## DETERMINATION OF NON-SIGNIFICANCE

**DESCRIPTION OF PROPOSAL:** Overlake Medical Office Building: To construct a new 130 foot tall medical office building with 7 levels of office and 7 levels of parking. The building will be 182,467 gross square feet with 740 parking stalls. Approximately 4,400 square feet of retail will be provided at the street level. Project will include landscaping and associated utilities. Project also includes demolition of two existing medical office buildings (total 29,000 gross square feet). The site area is 1.44 acres.

**FILE NUMBER:** 09-102901-LD

Proposal Title: **OVERLAKE MEDICAL OFFICE BUILDING**

**SHEET TITLE / NUMBER**  
PRIVATE  
ROAD PLAN  
**C4.2**

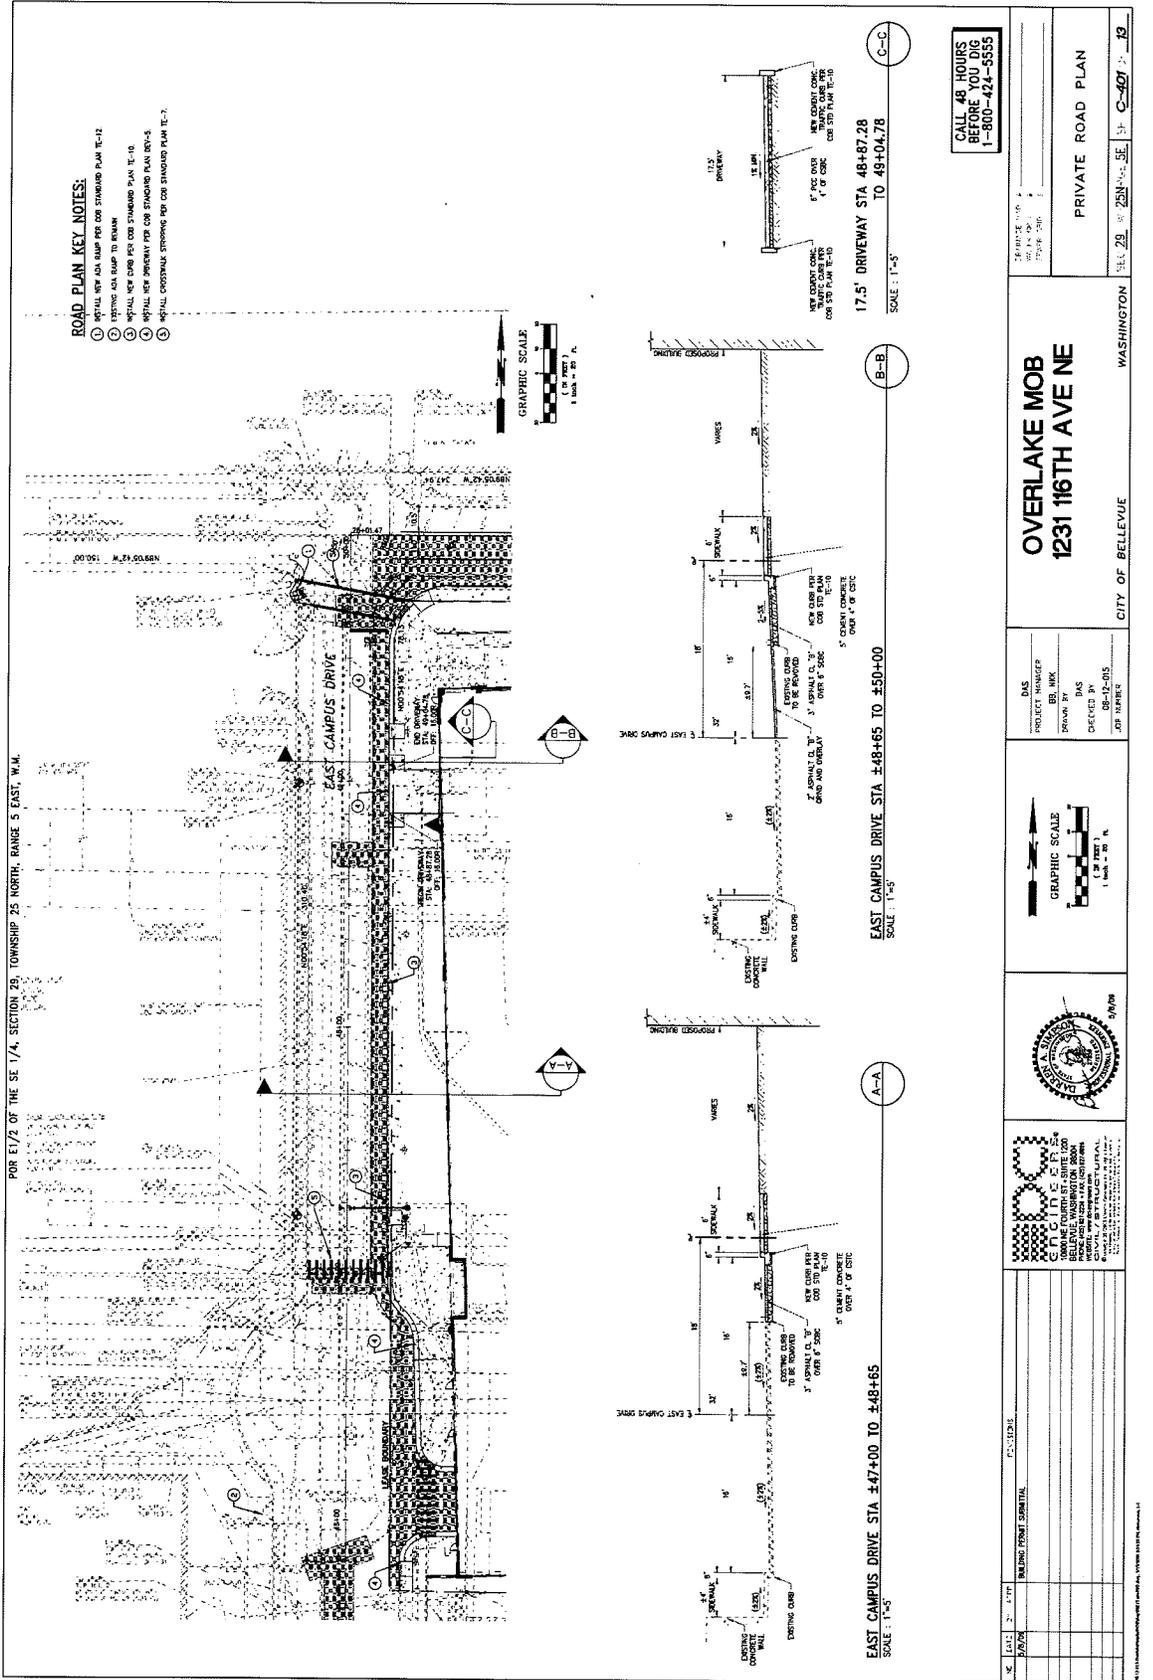
6. The proposed driveway on 116<sup>th</sup> Avenue NE shall have an approach width, as defined in standard drawing DEV-6, of 26 feet. The driveway apron design shall be consistent with standard drawing DEV-6. The existing north driveway modification shall be constructed per civil plans design and details submitted on June 10, 2009.

**SHEET TITLE/NUMBER**  
116TH AVE NE  
ROAD PLAN

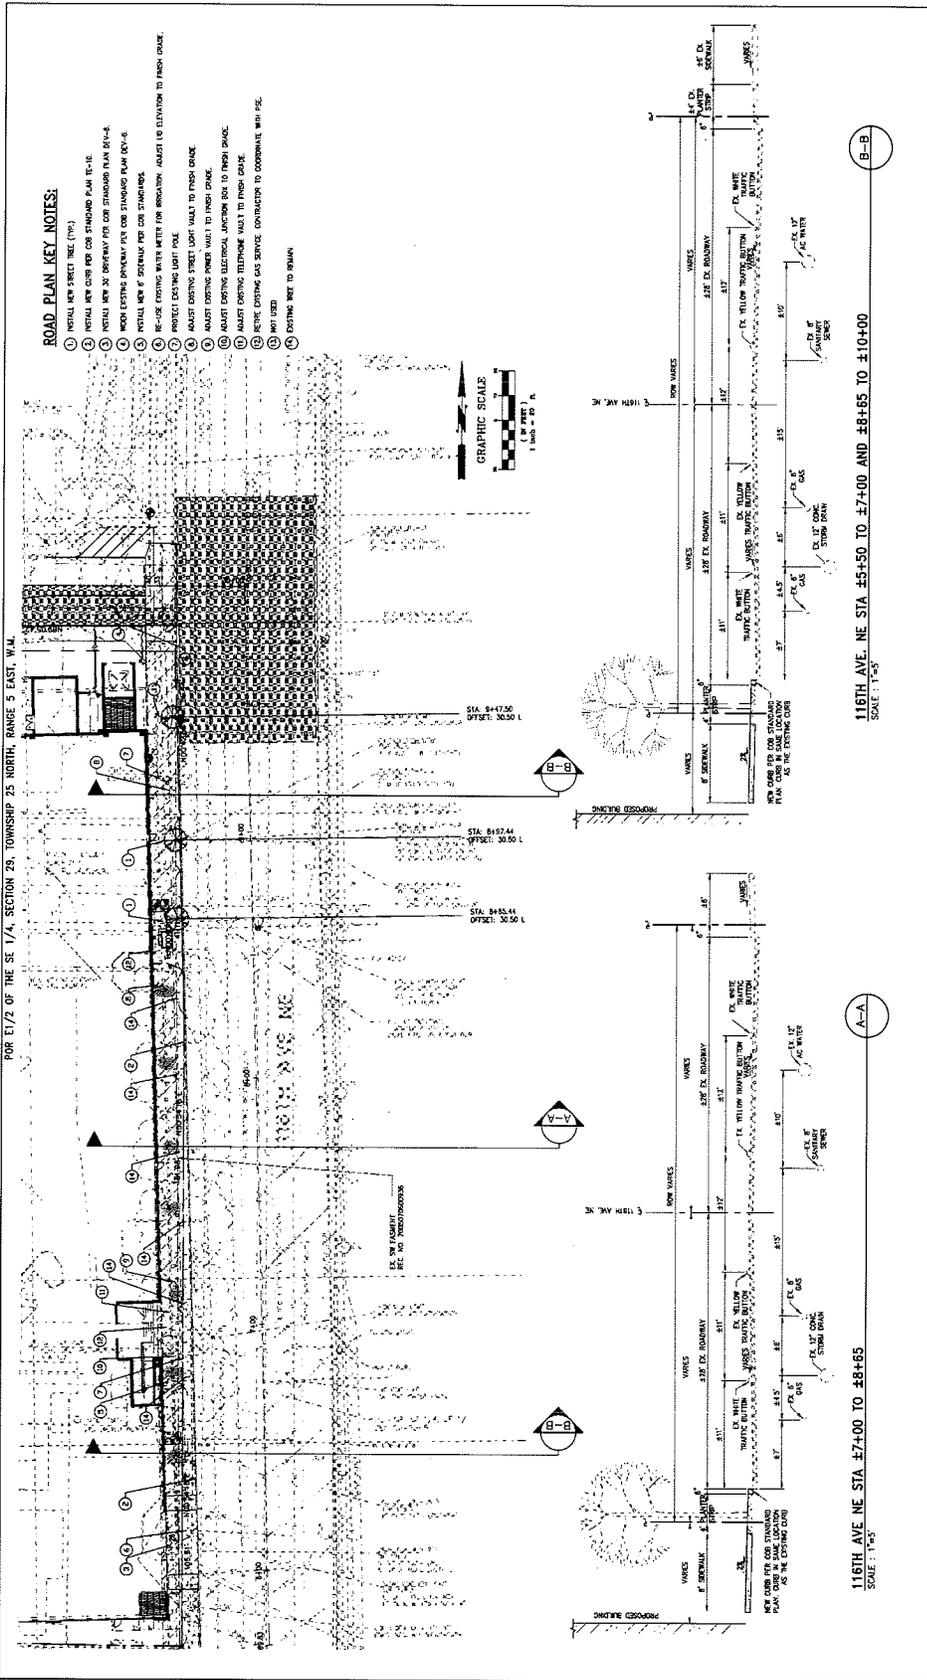
This project provides the necessary eight foot wide sidewalk plus four feet for street plantings plus six inches of curb. Seven (7) existing City street trees (London Planes) within the 116<sup>th</sup> Avenue NE right-of-way will be protected and retained. See plan sheets C1.1, C4.1 and L1.01.

3. The curb, gutter, and sidewalk on 116<sup>th</sup> Avenue NE shall be completely removed (with the exception of street trees to be saved) and reconstructed with 8' sidewalk, 4' planting strip and 6" curb. A street profile must be submitted with construction plans.
4. The design and appearance of the sidewalk and landscaping on 116<sup>th</sup> Avenue NE shall comply with the standards and drawings in the Transportation Department Design Manual, including standard drawings TE-11 and DEV-3. The 8' wide sidewalk shall be constructed of standard concrete with a broom finish and a two-foot by two-foot score pattern, with four foot wide planting strip and 6" curb, unless both the Transportation Department and the Development Services Department agree to accept any non-standard pattern, color, or other features.

SHEET TITLE/NUMBER  
**GARAGE  
LEVEL P5 & P4  
FLOOR PLANS**  
**A2.1**

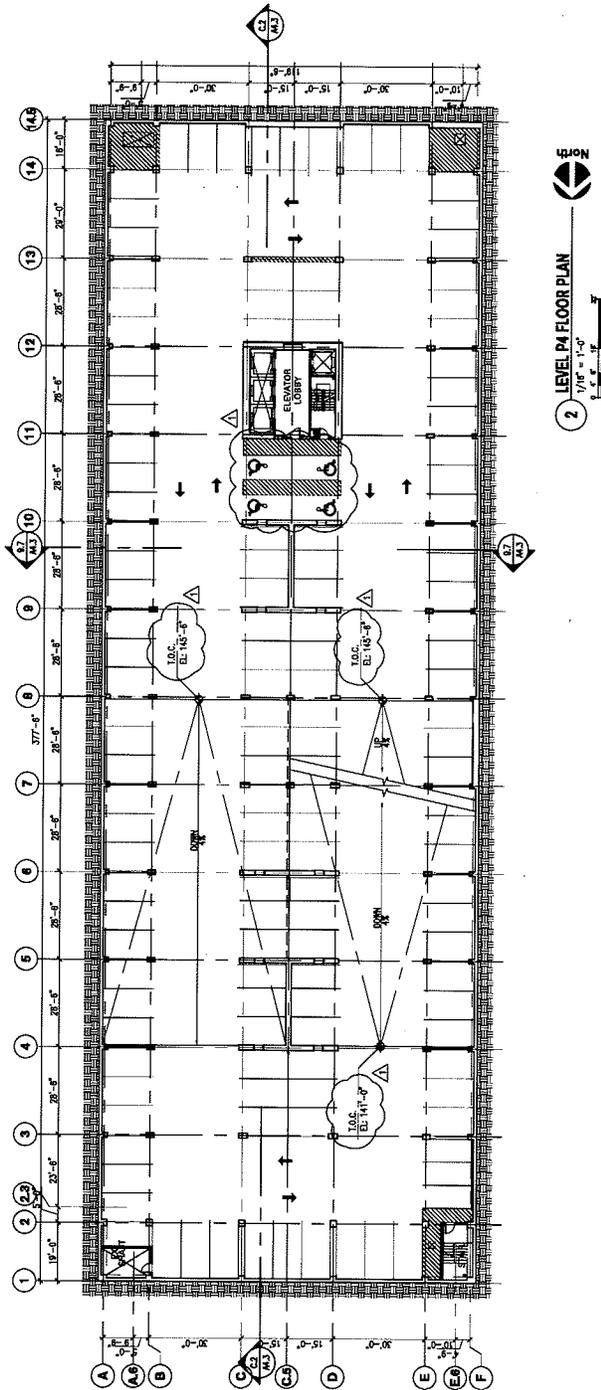
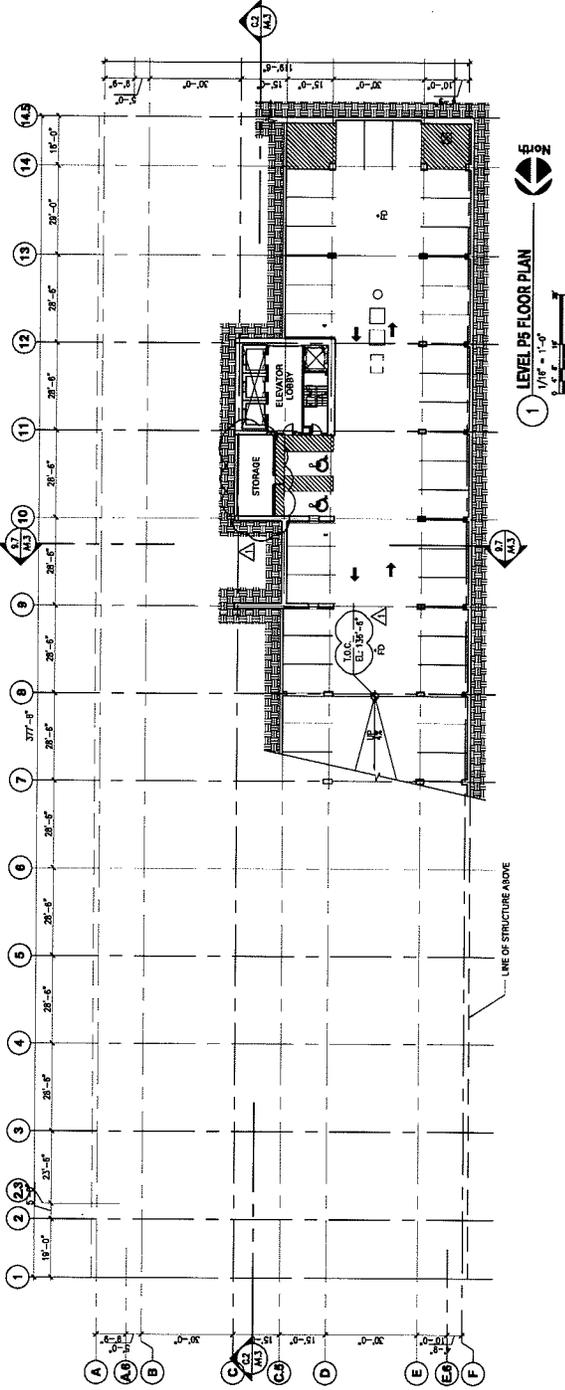
Safe pedestrian connection is provided between the parking structure and the principal use since parking is located within the building with 7 levels of parking. See plan sheets A2.1-A2.4.

SHEET TITLE / NUMBER  
**PERSPECTIVE  
FROM  
SOUTHEAST**

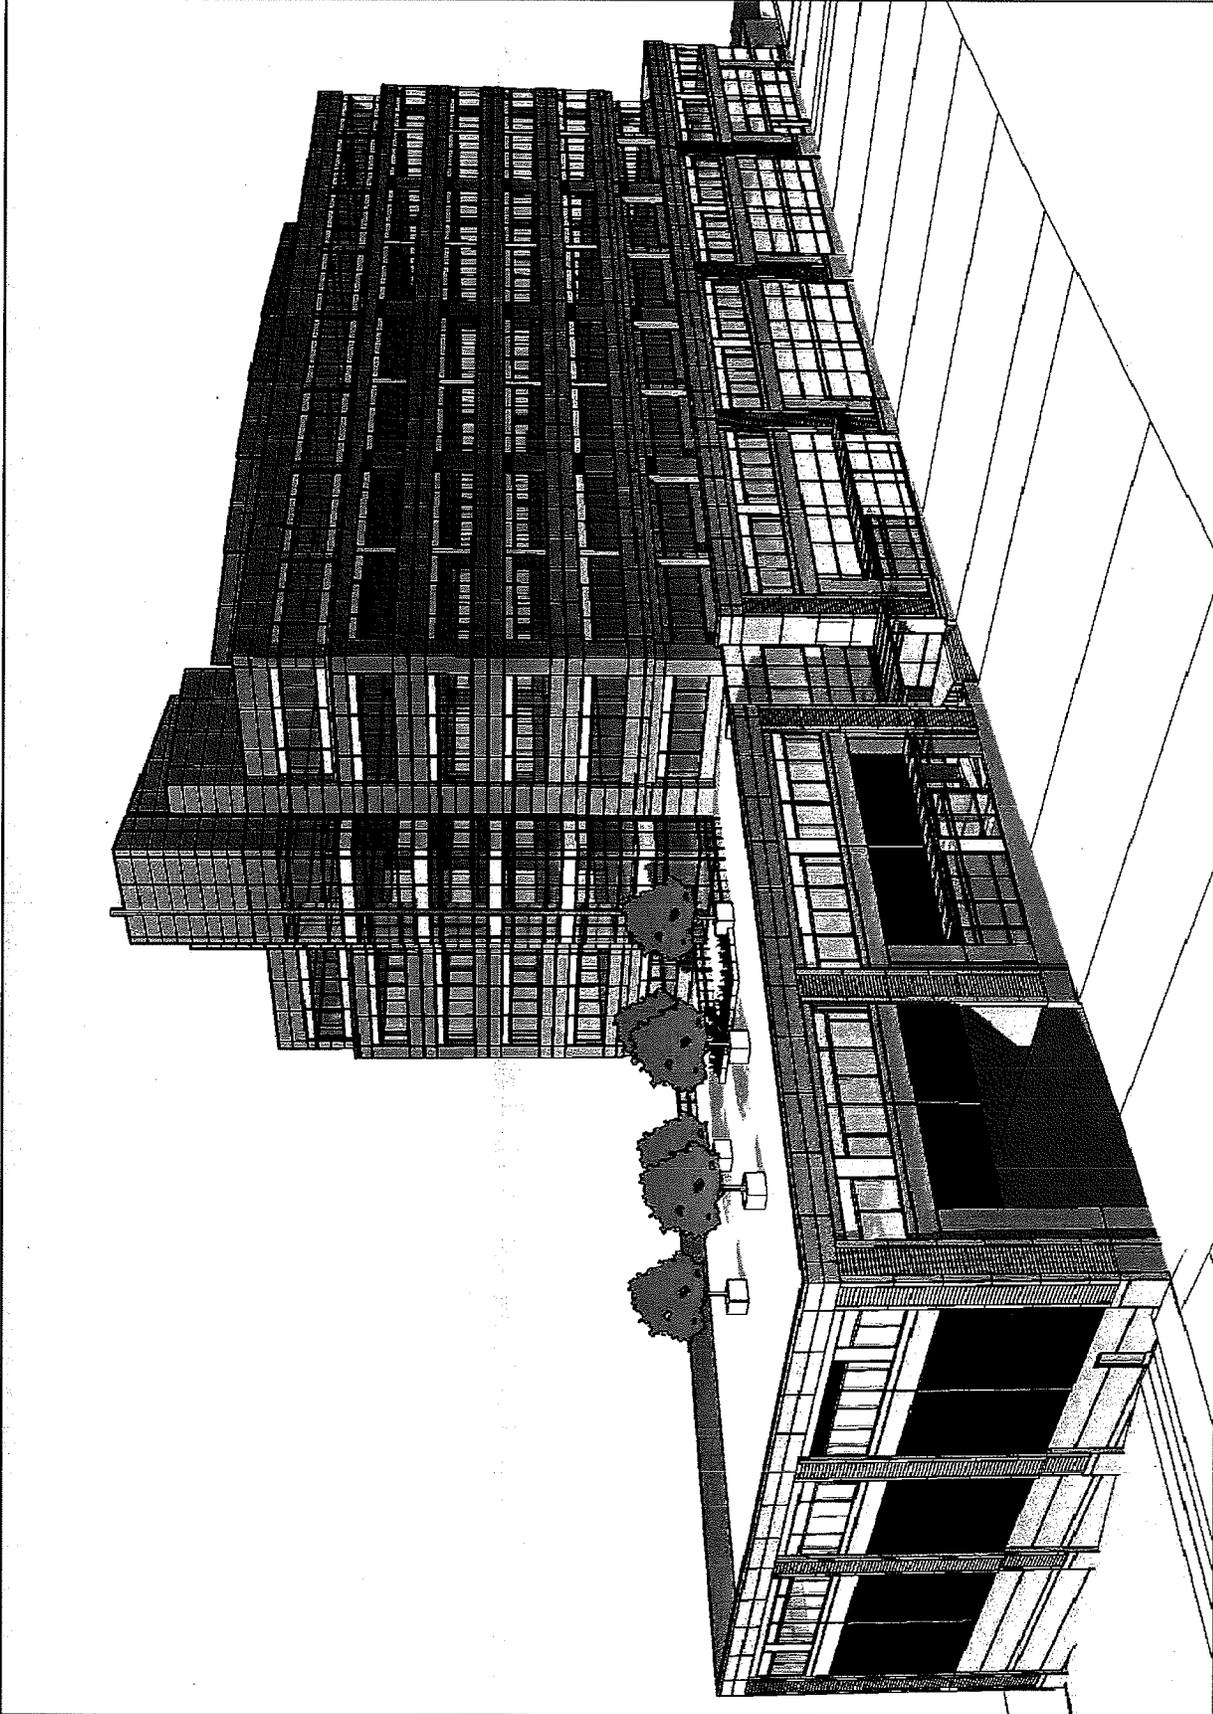
The parking component of this project is within the building. Two floors of parking are located above the sidewalk level and are screened by special window glazing and architectural design of the façade. See plan sheet A5.2.
